**Storm Drainage BMPs In the Vicinity of Kaelepulu Pond
Contract No. F-33975(D)
Task IV, Deliverable I – Conceptual Design Submittal**

AECOM has prepared the following letter to present the conceptual design plans, drainage report, and preliminary cost estimate for the project titled: Storm Drainage BMPs In the Vicinity of Kaelepulu Pond.

SITE PLAN 1 - CATCH BASIN FILTERS

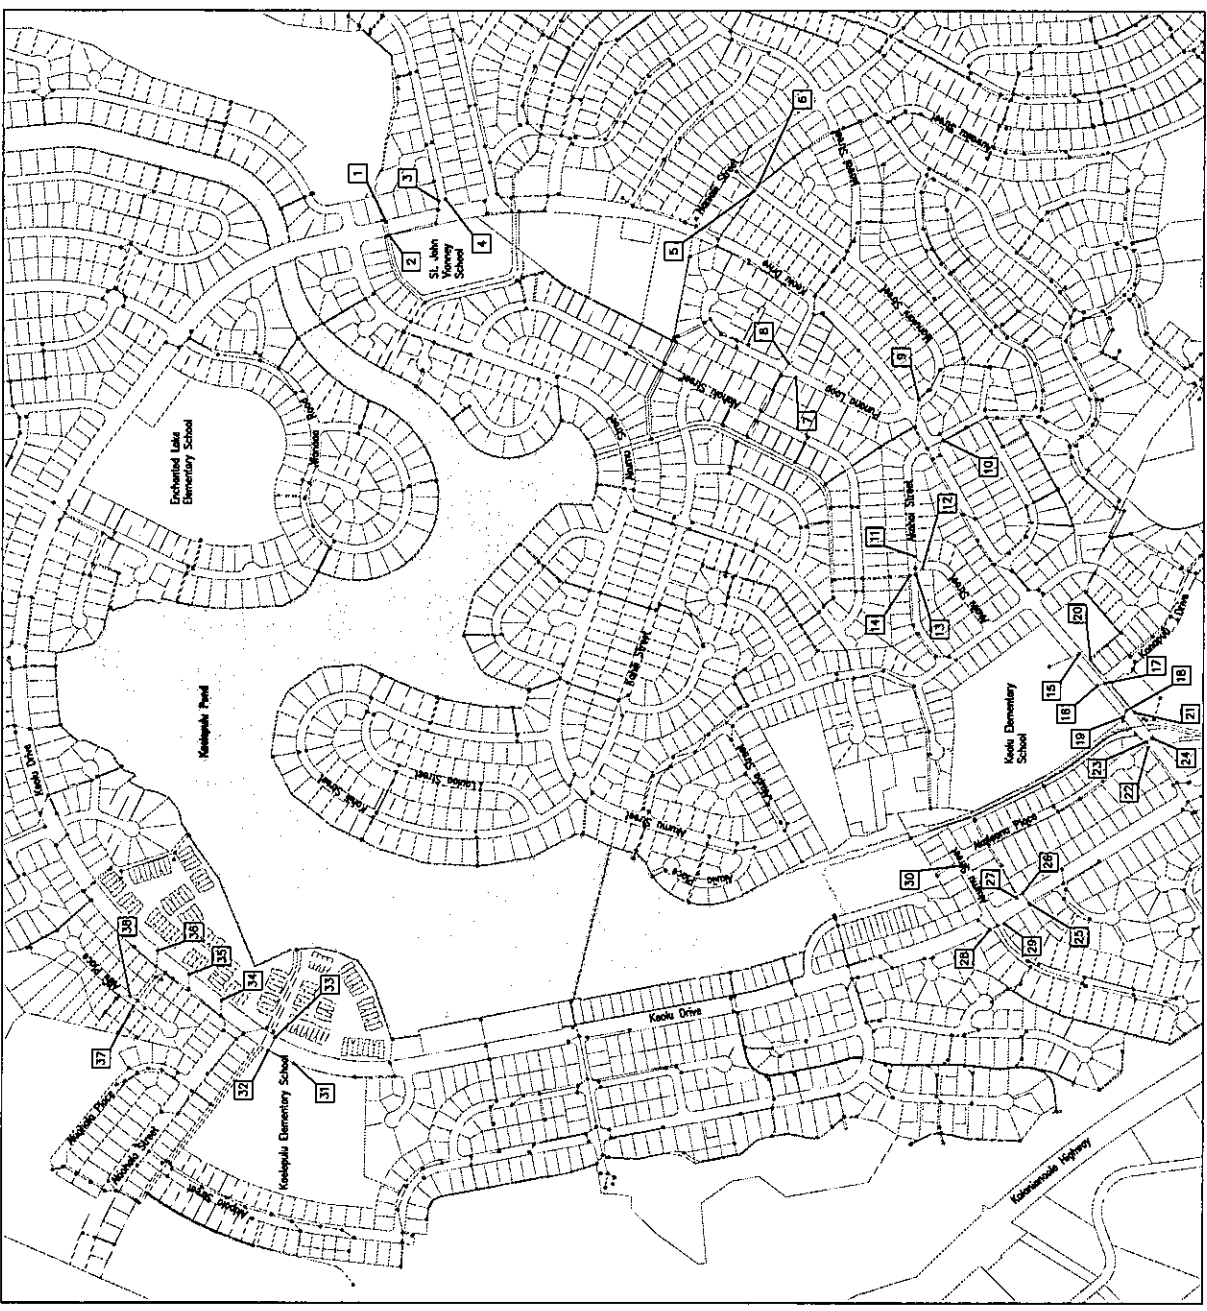
Shows location of curb inlet basket BMPs of types A,B,C,&F
